SERVICE NO. 1093B LETTER

ELECTRICAL CONTACTOR REPLACEMENT KIT

SL 1093B includes revised instructions in which the contactor replacement kit for some models has changed.

**KIT ~ ELECTRICAL
CONTACTOR REPLACEMENT**

SECTION II: IDENTIFYING OLD vs REPLACEMENT CONTACTOR

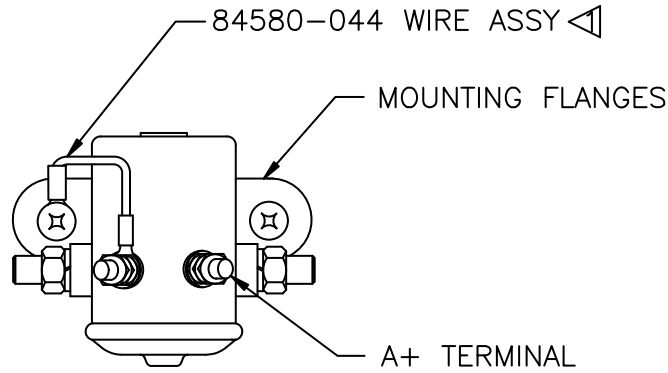
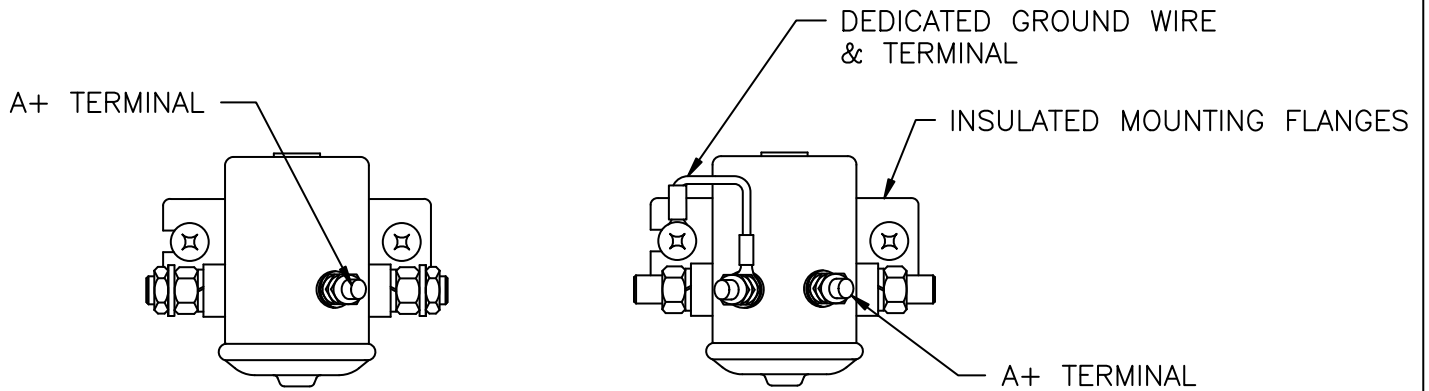
Ⓔ	PAC 26898-002 (487-149) (6V INTERMITTENT)	→	PAC 26898-010 (602-850) (6V INTERMITTENT)
	PAC 26898-003 (487-152) (12V INTERMITTENT)	→	PAC 26898-008 (584-420) (12V INTERMITTENT)
	PAC 99130-002 (487-169) (6V INTERMITTENT)	→	PAC 99130-003 (602-847) (6V INTERMITTENT)
Ⓔ	PAC 26898-010 (602-850) (6V INTERMITTENT)	→	PAC 26898-013 (584-460) (12V INTERMITTENT)
Ⓔ	PAC 26898-008 (584-420) (12V INTERMITTENT)	→	PAC 26898-011 (584-461) (24V INTERMITTENT)
Ⓔ	PAC 99130-003 (602-847) (6V INTERMITTENT)	→	PAC 26898-013 (584-460) (12V INTERMITTENT)
			PAC 99130-004 (584-460) ◀ (12V INTERMITTENT)
Ⓔ	PAC 26898-006 (487-163) (6V INTERMITTENT)	→	PAC 26898-013 (584-460) (12V INTERMITTENT)

SECTION II: IDENTIFYING OLD vs REPLACEMENT CONTACTOR (CONTINUED)

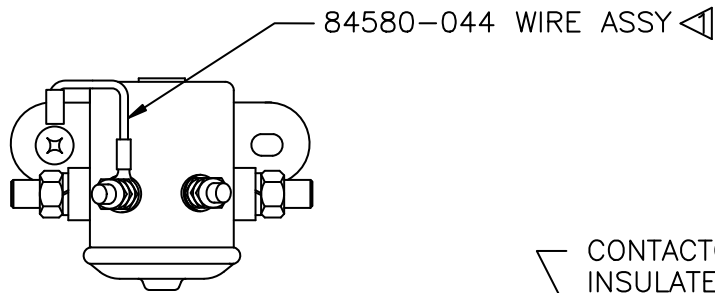
CONTACTOR CHANGED TO INSULATED MOUNTING FLANGES

The 487-157 Contactor was not changed to include insulated mounting flanges. The contactor without insulated mounting flanges is available from our Dealer Network.

STARTER CONTACTOR ASSEMBLY (OLD CONTACTORS)

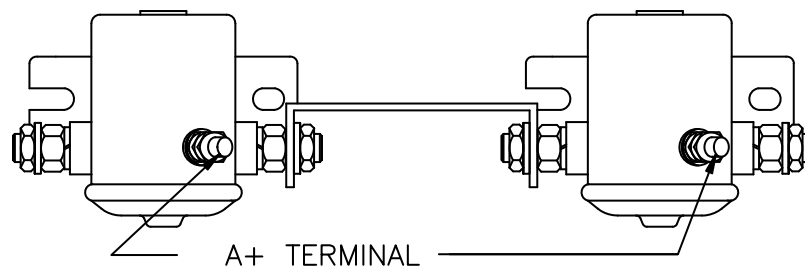
See View A for attachment of Ground Wire to airframe ground.

VIEW B

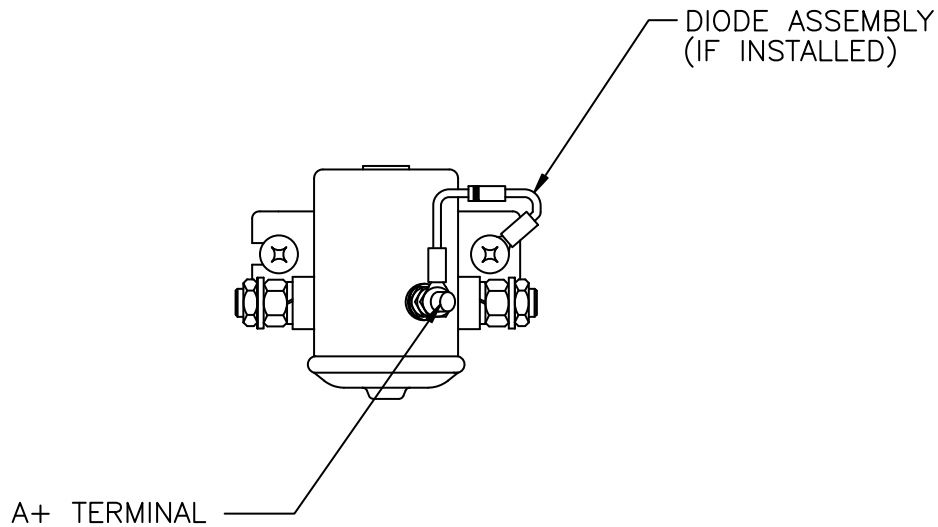
1.2.b. See View B for attachment of Ground Wire to airframe ground for the following aircraft.

If the existing contactor installation includes a diode assembly installed between the A+ terminal on the contactor and the airframe ground, the diode must be reinstalled on the replacement contactor. Confirm that ID band (cathode) on the diode is towards the A+ terminal.

VIEW B (CONTINUED)

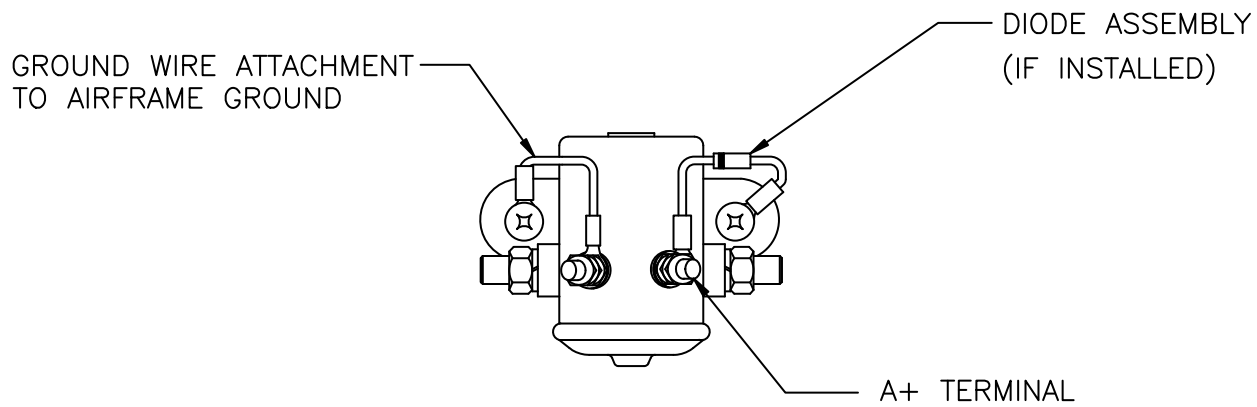
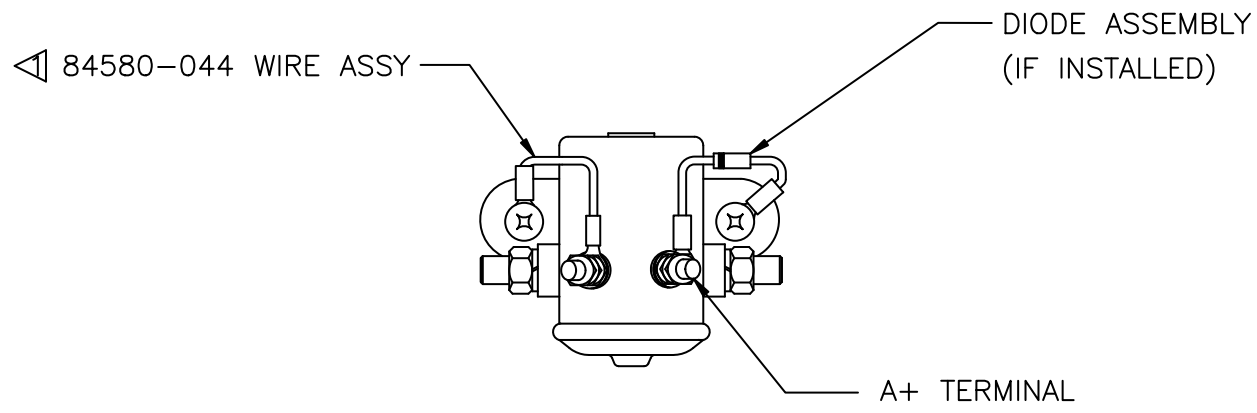
If the existing contactor installation includes a diode assembly installed between the A+ terminal on the contactor and the airframe ground, the diode must be reinstalled on the replacement contactor. Confirm that ID band (cathode) on the diode is towards the A+ terminal.
